***Sydney Super Yacht Marina  
(MP 09\_0165 MOD 2): Modifications to  
Western Building***

Secretary's  
Environmental Assessment Report  
Section 75W of the  
*Environmental Planning and Assessment Act 1979*

May 2015

For comparative purposes, the approved and proposed ground floor and first floor levels for the Western Building are provided at **Figures 4 to 7** below.

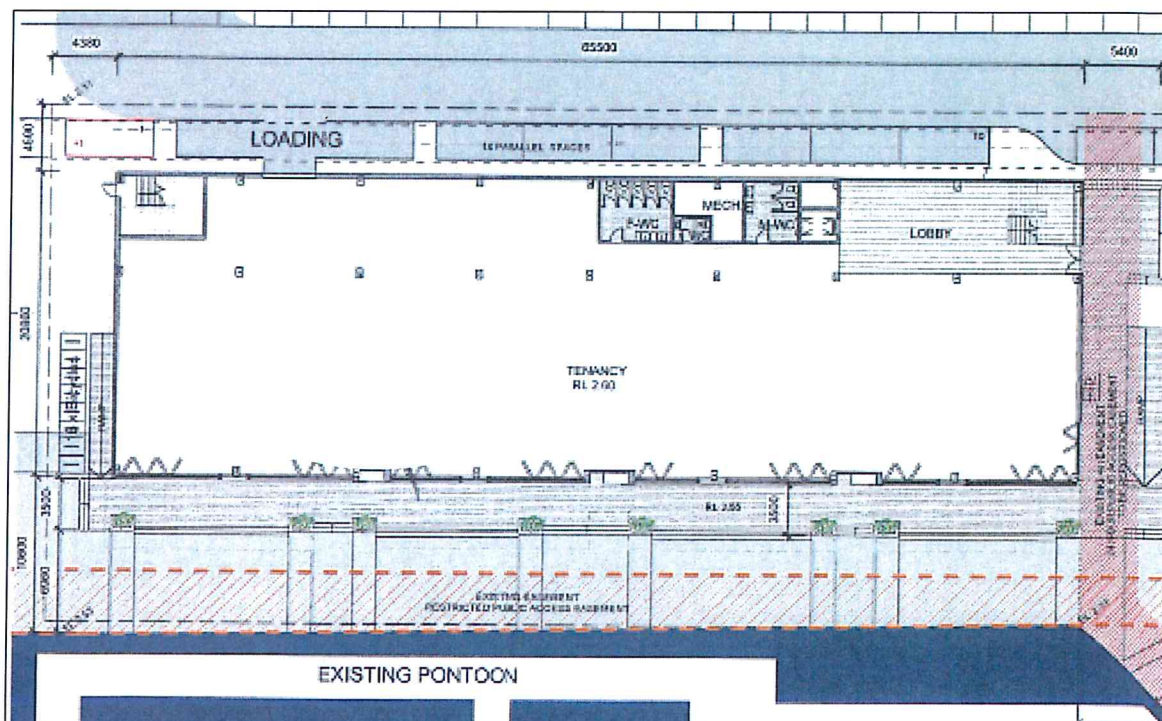
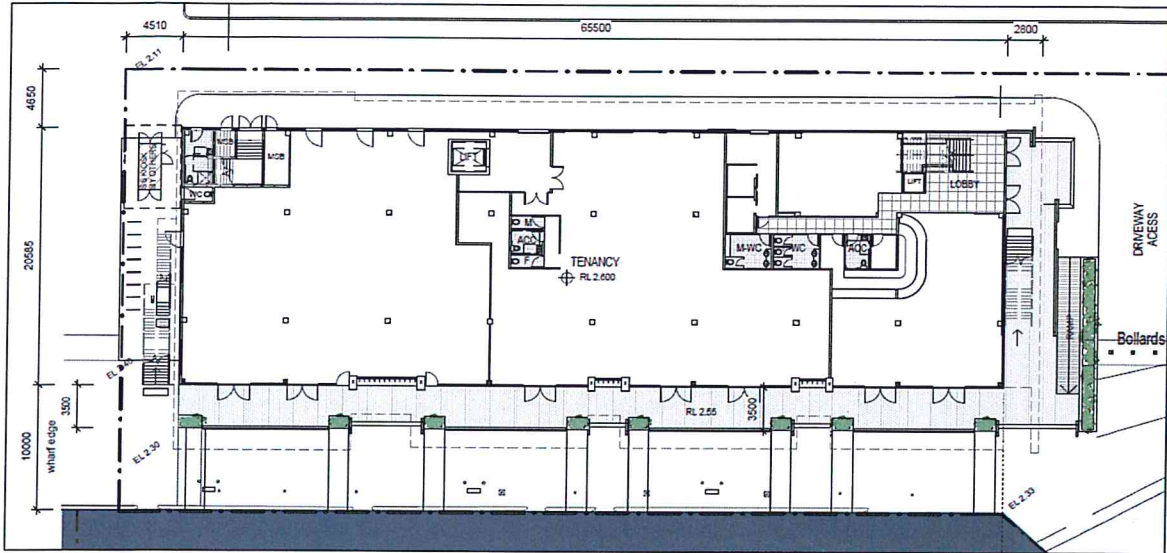
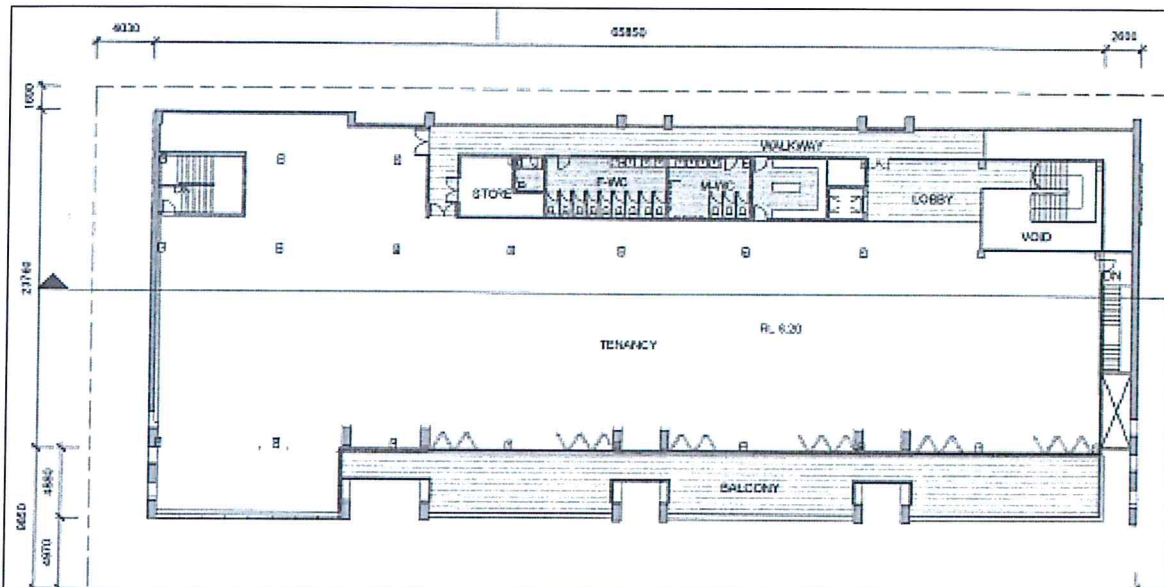
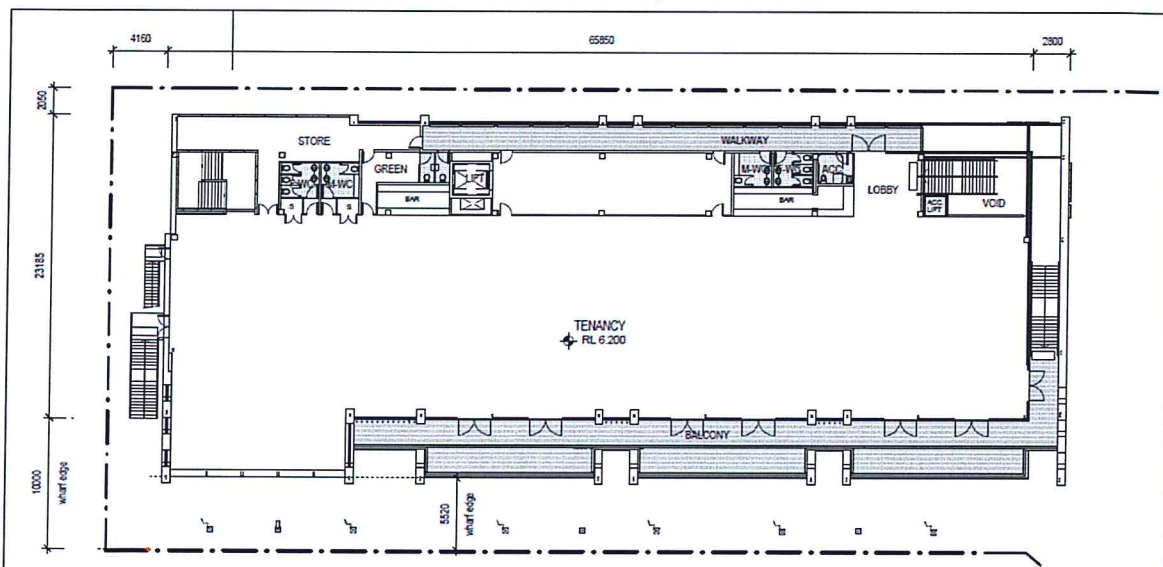
- to modify (and reduce) the width of the balconies and roof overhang by 400mm on the southern elevation of the Western Building to provide for a consistent setback to the wharf edge;
- to amend the location and configuration of the approved land uses on the ground floor level of the Western Building (i.e. marine, yacht club and provedore);
- to construct two external fire stairs on the western elevation;
- to remove the airlocks on the first floor level of the Western Building;
- to remove 13 car parking spaces at the rear of the Western Building; and
- other minor design amendments, including the relocation of lifts.

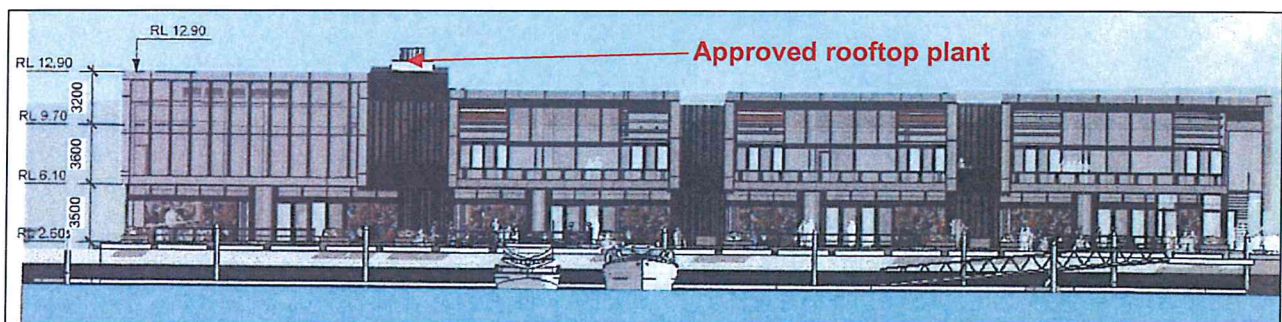
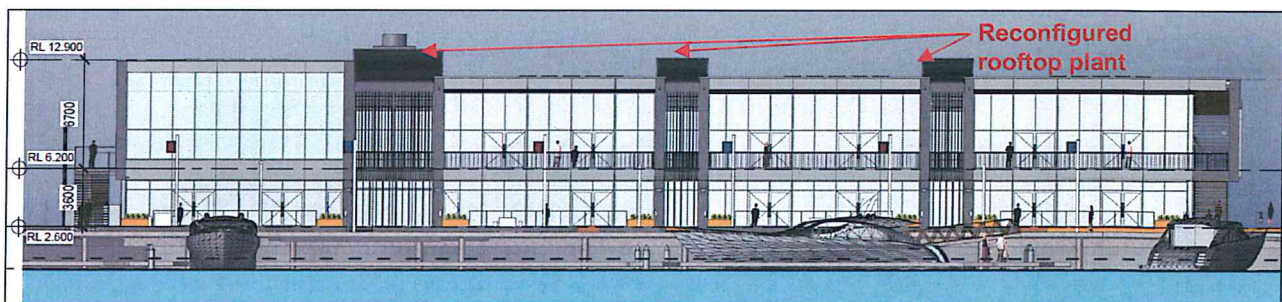
Figures 8 and 9 below illustrate the approved and proposed southern elevations of the Western Building, respectively. Figure 9 illustrates that the design refinement of the Western Building will result in minimal changes to the approved built form when viewed from the waterfront and in this regard, that the modified development will remain substantially the same as the approved development.

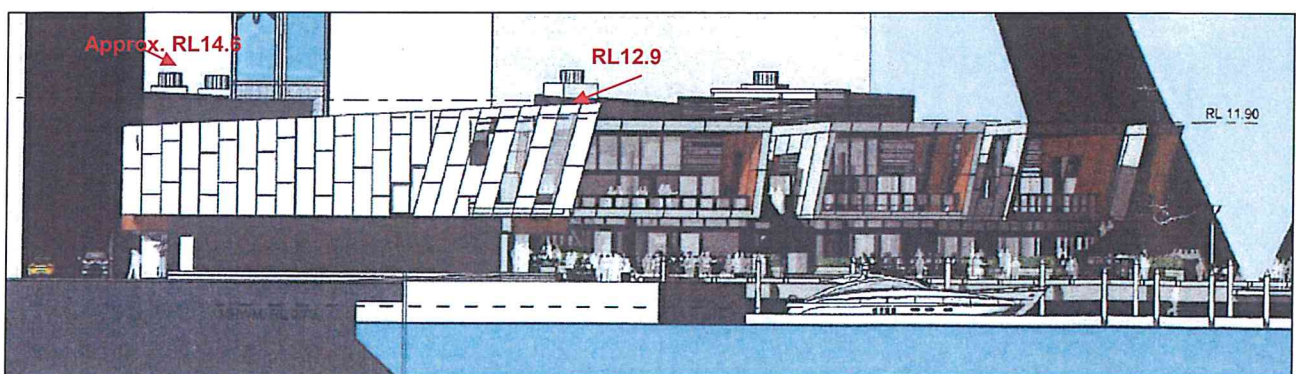
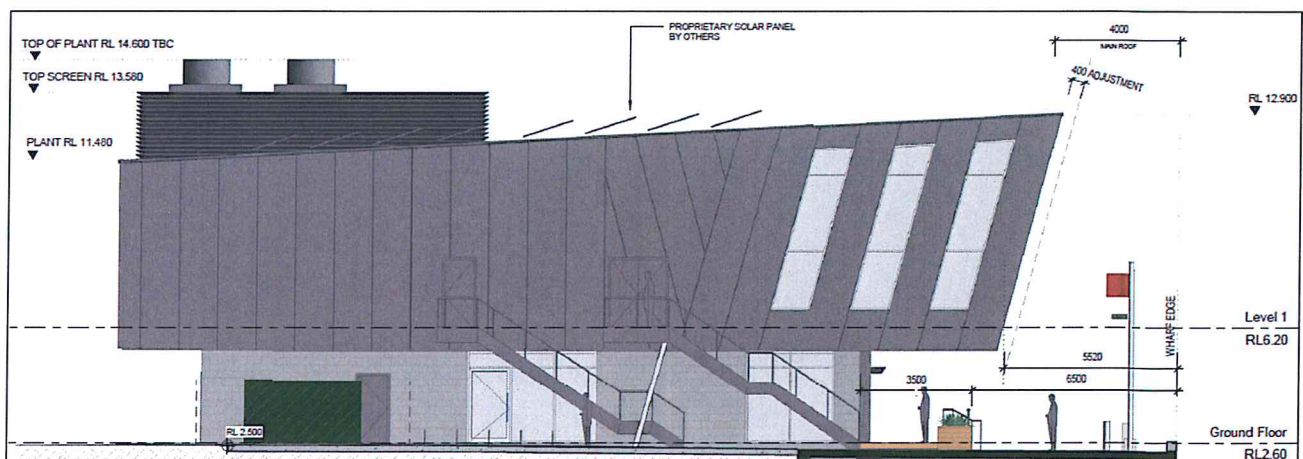
MOD 2 proposes minor changes to the roof form and the rooftop plant as illustrated in Figure 9 above. The overall height of the roof (when measured to the southern edge of the

roof parapet) retains a maximum height to RL12.9 (noting that it includes components at RL11.90) and therefore, remains generally consistent with the current approval.

The Department notes that the height of the rooftop plant was not nominated on the approved drawings. Notwithstanding this, the Department is satisfied that the proposed plant height is generally consistent with the approved development, as illustrated in **Figures 10** and **11** below. The amended drawings confirm that the building plant will achieve a maximum height of RL14.6m or approximately 12.0m. This represents a 4m height non-compliance with the height limit in *Rozelle and Blackwattle Bays Precinct Master Plan 2002*. Whilst the configuration of the roof top plant is proposed to be amended (i.e. it is proposed in 3 location on the rooftop, rather than being consolidated in one location), it remains located at the northern end of the building, is suitably screened and integrated into the building design and will not be visible from the waterfront promenade. For these reasons and given the proposed height remains consistent with the height of the approved building, the Department raises no objection to this aspect of the proposal.

**Figure 12:** Cross Section through Western Building (Source: Scott Carver)

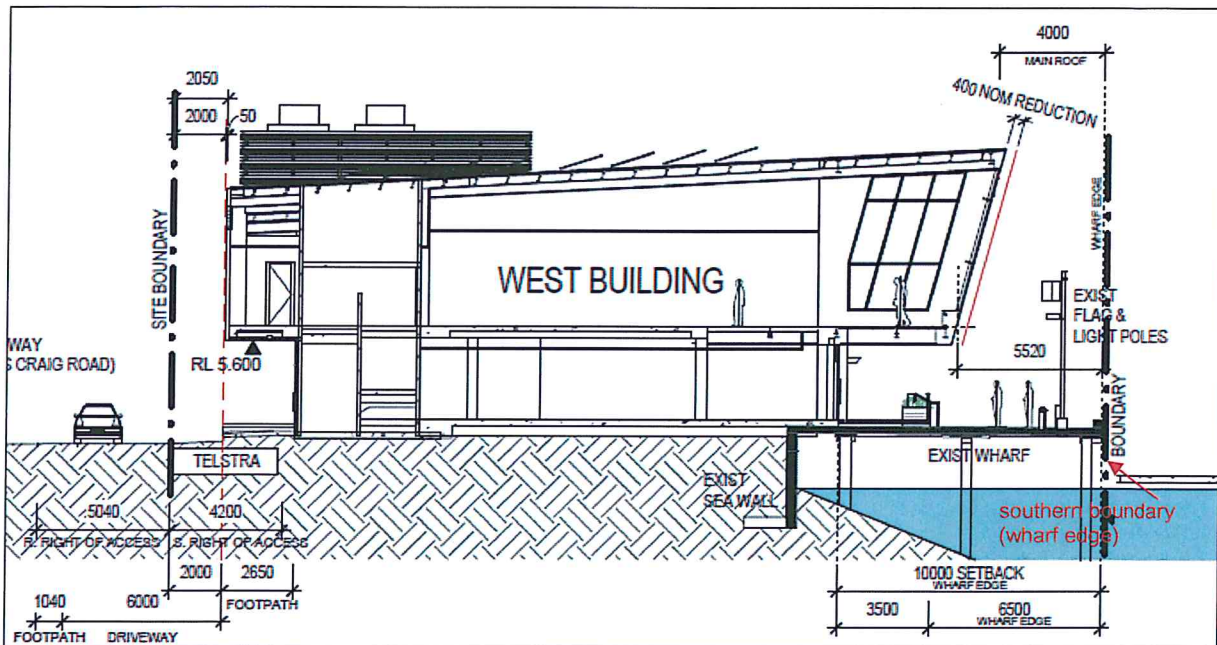
In summary, the amended plans submitted with MOD 2 propose the following setbacks, as illustrated in **Figure 12**:

- the southern edge of the roof parapet is setback a minimum of 4m from the wharf edge (an increase of approximately, 400mm);
- the southern edge of the first floor level of the building is setback approximately 5.52m from the wharf edge;
- the southern edge of the ground floor level of the building is setback generally 10m from the wharf edge with 3.5m adjacent to the building comprising an outdoor deck (consistent with the existing project approval); and
- the setback to the northern boundary has increased by 0.60m and 0.360m to 4.65m 2.05m and in respect to the ground floor and first floor levels of the building.

As detailed above, the ground floor level setback when measured from the southern elevation of the Western Building to the wharf edge (southern boundary) is proposed at 10m and would comply with the 10m setback nominated in the *Rozelle and Blackwattle Bays Precinct Master Plan 2002*. However, the setback to the wharf edge at Level 1 and in respect to the roof parapet would remain non-compliant (as is the case with the approved project), albeit that the setback has increased by 400mm under MOD 2 and represents an overall design improvement.

The Department considers that the amended plans have satisfactorily addressed and resolved previous concerns raised in relation to the building setbacks to the wharf edge and in this regard, provide certainty with respect to the set-out of the public domain, including public access along the waterfront (which is defined by a 4.0m wide public easement).

A condition is recommended to ensure that the constructed building is certified as complying with the setbacks to the southern boundary (wharf edge).

**Figure 13:** Approved and proposed plans showing distribution of floor space.

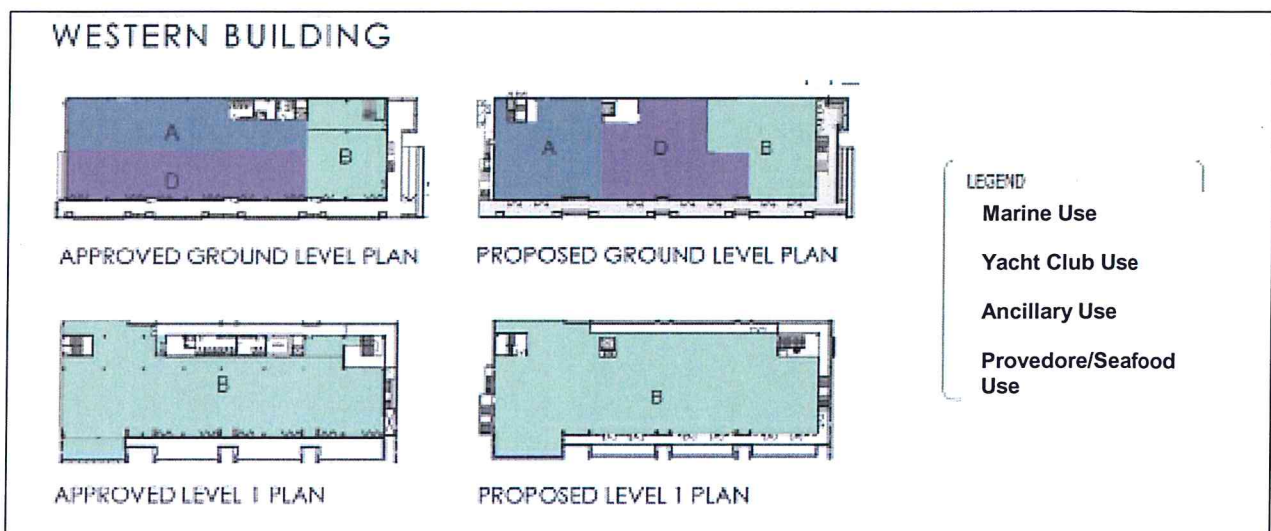
MOD 2 proposes a minor decrease in the quantum of GFA allocated to the Western Building as result of minor changes to the floorplate configuration and the internal configuration of the land uses. The total GFA for the Western Building is proposed to reduce by 255m<sup>2</sup> to a total of 2,645m<sup>2</sup>, resulting in the overall GFA for the development being reduced to 5,945m<sup>2</sup>. The proposed changes in the GFA is detailed in **Table 1**.

The Department notes that the proposed changes to the GFA including the distribution of uses within the Western Building remain generally consistent with the objectives for the 'waterfront use' zoning which applies to the site pursuant to SREP 26. The changes to the GFA allocated to each land use is illustrated graphically in **Figure 13** below.

Conditions A6 and E8 were imposed on the Project Approval to restrict the overall quantum of GFA allocated to ancillary uses and to ensure that maritime uses remain the dominant land use within the development (and that this would not be eroded over time). The Department notes that the current proposal does not exceed the GFA allocated to ancillary uses of 1,417m<sup>2</sup> or 22.9% currently nominated in Condition A6 and E8, as 1,402m<sup>2</sup> or

23.58% of the total GFA for the project is now proposed. To ensure that the GFA distribution accurately reflects the proposed changes, the Department recommends that Conditions A6 and E8 be amended accordingly.

**Figure 14:** Proposed building heights- Western Building

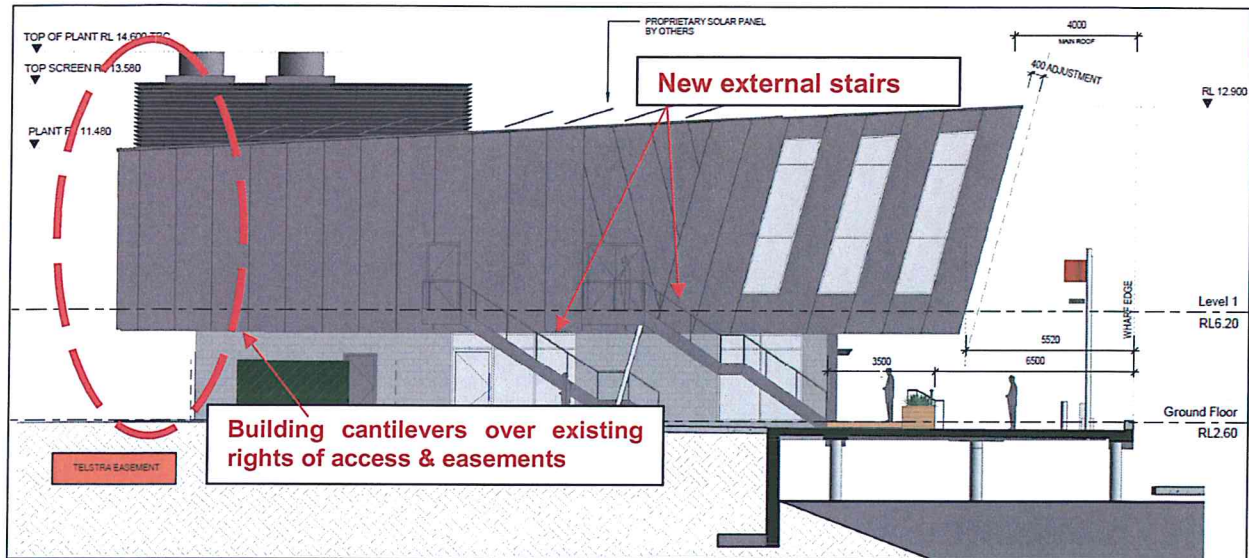
The RMS has advised that the approved and proposed Western Building (and multi-level car park) siting encroaches on a number of easements and rights of access which encumber the subject site. The building encroachment relates to the first floor level of the building which cantilevers over these easements and rights of access as illustrated in **Figure 14** below. The relevant easements and rights of access are listed below:

The Department notes that despite the building cantilevering over the Telstra easement, as illustrated in **Figure 14**, access to the telecommunication equipment for repair and maintenance is not impeded.

The modification application proposes the installation of two external stairs on the western elevation of the building, as illustrated in **Figure 14**. The Proponent has advised that the stairs are required to meet the requirements of the Building Code of Australia.

The proponent has submitted a copy of the Draft Section 88B Instrument pursuant to the *Conveyancing Act 1919* and the accompanying Draft Deposited Plan which proposes to release the existing relevant easements and rights of access which are impacted by the development and to create new easements and rights of access. Correspondence has also been provided from the RMS confirming that no objection is raised to the terms of the Draft Section 88B Instrument and the Draft Deposited Plan.

Having regard to the above, the Department is reasonably satisfied that the proposal can be determined and furthermore, that design amendments to the Western Building are not required to remove the encroachments.

The Department has considered the design and location of the stairs and raises no objection to this element of the modification application.
